Group submission relating to application SSD 5878

Sydney International Convention, Exhibition and Entertainment Centre Precinct – Mixed use Development in the Southern Haymarket Precinct (Concept Proposal) (SSD)

Many local residents of Haymarket consider the proposed developments for Darling Harbour (Convention Centre, Exhibition Centre, Entertainment Centre and Haymarket re-development) to be ill conceived and not in the best interest of either Sydney's residents or its visitors. The particular concern of this submission is SSD 5878, the Southern Haymarket Precinct.

74284 WCD AN 2357 01/03/2013	DENTON CORKER MARSHALL	THE HAYMARKET LEND LEASE DEVELOPMENT	DEVELOPMENT APPLICATION PEAK TOWER - NORTH ELEVATION PROPOSED BUILDING PROFILE OVERLAY
------------------------------	------------------------------	---	--

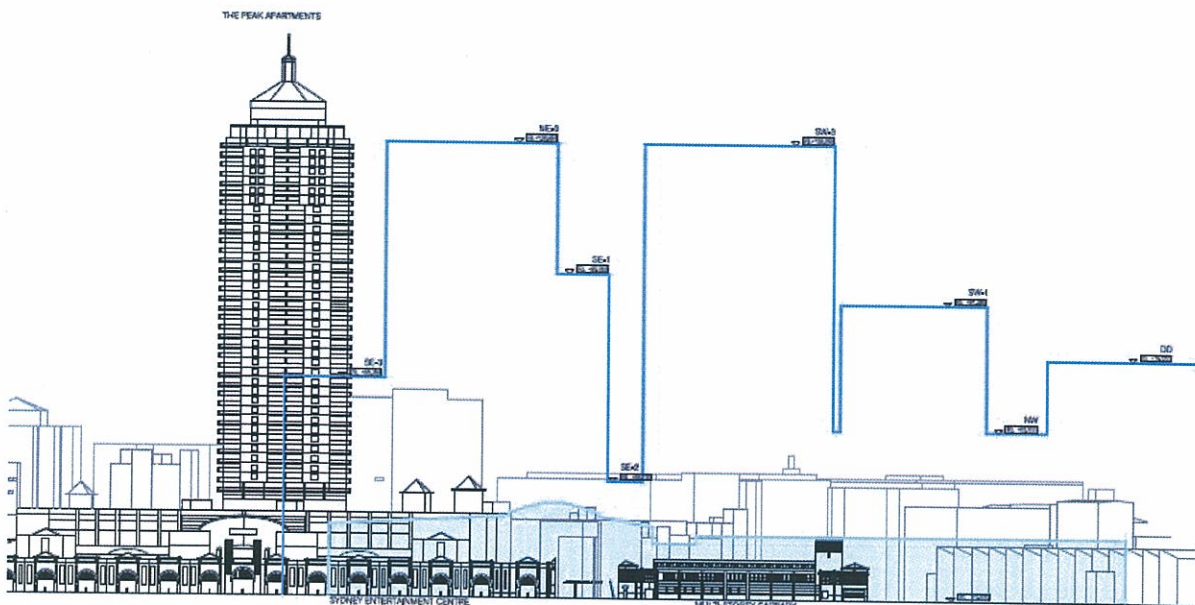
This shows these planning guidelines have been ignored in the drive for increased density and optimum placement of the new towers for maximum return - all with scant regard for the existing buildings.

The loss of amenities, outlook and views is an excessive burden on the residents of the Peak and for all the residents of surrounding buildings. At a minimum, it is imperative to delete the Tower SE1 from the planned development.

The following figure – buried in SSD 5755 illustrates the size of the proposal in relation to The Peak.

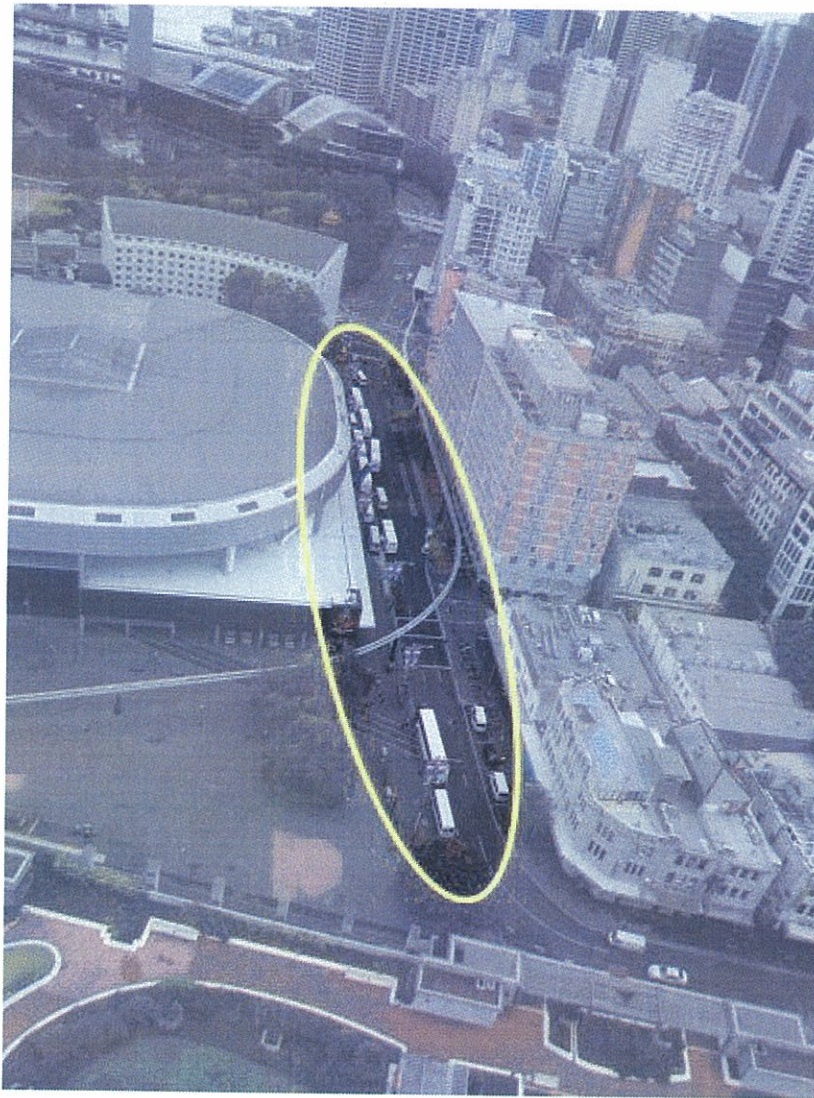
"Harbour Street is a one-way northbound road with three traffic lanes and one parking lane. At present, lane 1 (the western-most lane) is a designated bus drop off/ pick up area. However, as the demand for bus services is heavily governed by the existing entertainment centre, which will cease to exist post-development, **it has been assumed that the bus zone will be removed** and this traffic lane will henceforth operate as a full-time travel lane with no kerb side parking permitted."

At present, tour buses line up each morning on Harbour Street to pick up tourists from the local hotels (The Holiday Inn, The Rockford Novotel, The Seasons and The Quest), for day trips and for the Airport run. There is space for about 6 buses. At the peak times there are often another 6 double parked, since they have nowhere else to go. Now this is to be reduced to 'No parking' or 'No Stopping'.

With the 2 entry points to the precinct on Harbour Street, this is going to generate severe problems for all parties.

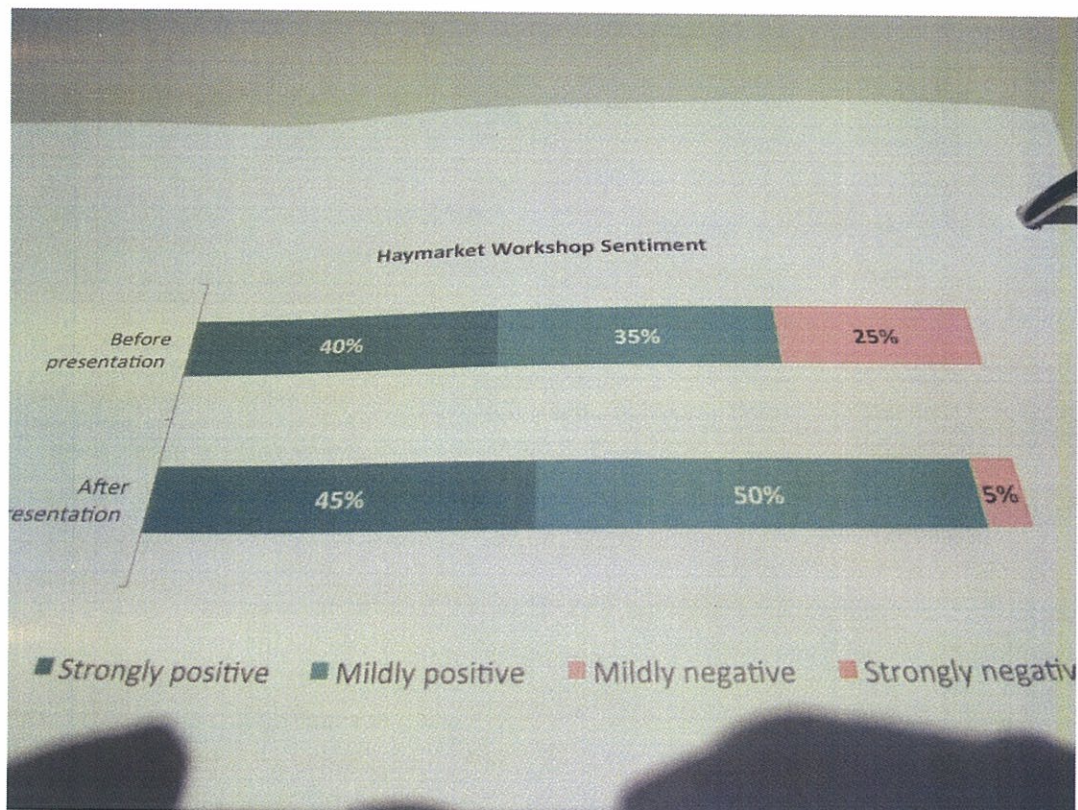
The student blocks and tower SW 1 will obscure the sight lines to the Museum from the southwest and the CBD. Why is it deemed sufficient to retain only the western façade when the eastern façade is the most important one.
